MANDATORY SERVICE BULLETIN**NUMBER:** SB11-11**REVISION:** 00**DATE:** Oct 20, 2011**SUBJECT:** BATTERY BOX REWORK**EFFECTIVITY:**

The accompanying Field Service Instruction provides guidance for modifying the Kodiak 100 battery box to increase fatigue life. Contact Quest Customer Service for Service Kit P/N FSI-023.

FIELD SERVICE INSTRUCTION

This Field Service Instruction provides guidance for reworking the Kodiak 100 battery box to increase fatigue life.

Figure 3-1: Drill-Down for Fastener Removal

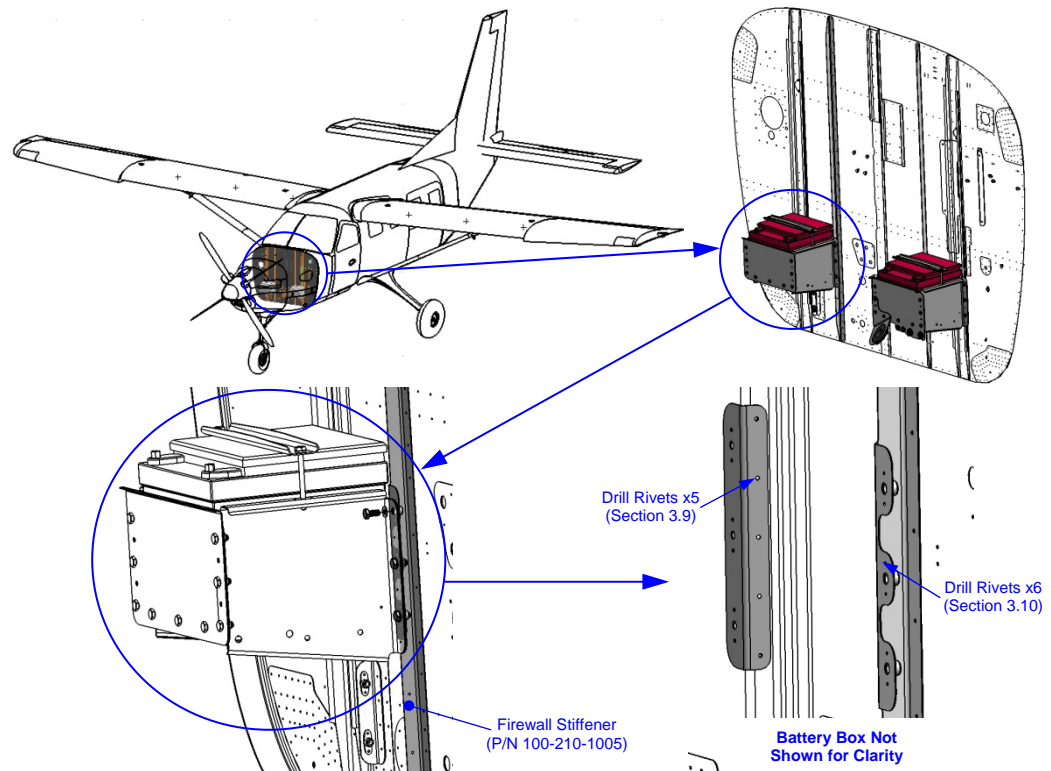
Drill out the five (5) fasteners securing each of the aluminum battery box mounting brackets (P/N **100-210-1027**) to the firewall; refer to **Figure 3-1**. Remove and discard the mounting brackets.

Drill out the two (2) fasteners securing each nut plate to the stainless steel firewall stiffener; refer to **Figure 3-1**. Remove and discard the nut plates.

Figure 4-1: Battery Box Bracket Installation

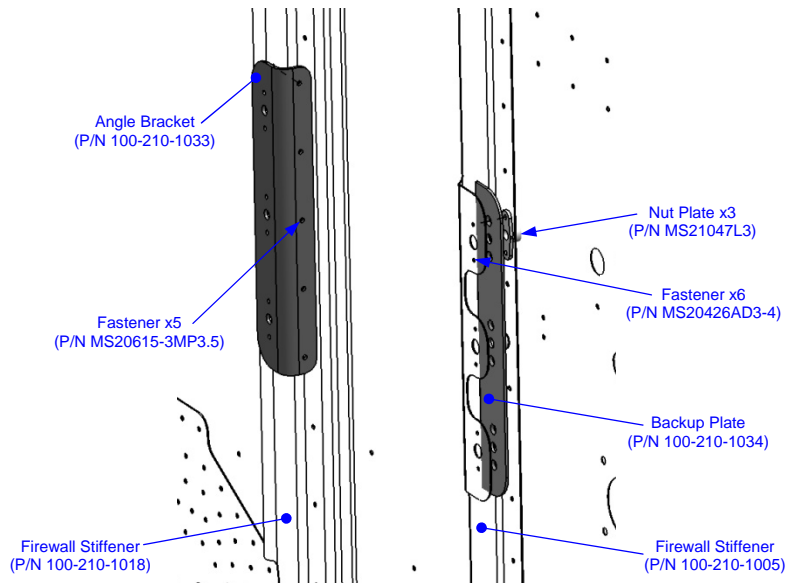
Position and secure the backup plate (P/N **100-210-1034**) and three (3) nut plates (P/N **MS21047L3**) using six (6) **MS20426AD3-4** fasteners; refer to **Figure 4-1**. This installation is mirrored on the opposite side of the aircraft.

Position and secure the aluminum angle bracket (P/N **100-210-1033**) using five (5) **MS20615-3MP3.5** fasteners; refer to **Figure 4-1**. This installation is mirrored on the opposite side of the aircraft.

Figure 4-2: Backplate Installation

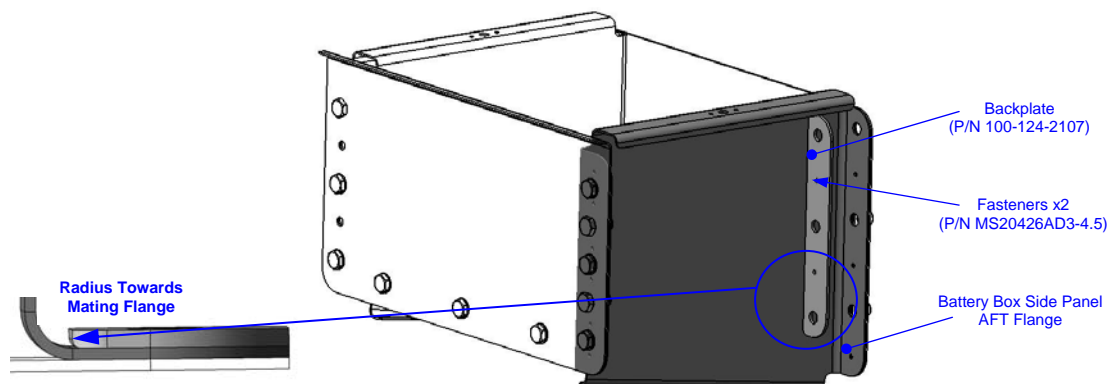
Position the backplate (P/N **100-124-2107**), ensuring that the radius on the backplate is facing toward the mating flange. Secure using two (2) **MS20426AD3-4.5** fasteners; refer to **Figure 4-2**. This installation is mirrored on the opposite side of the aircraft.
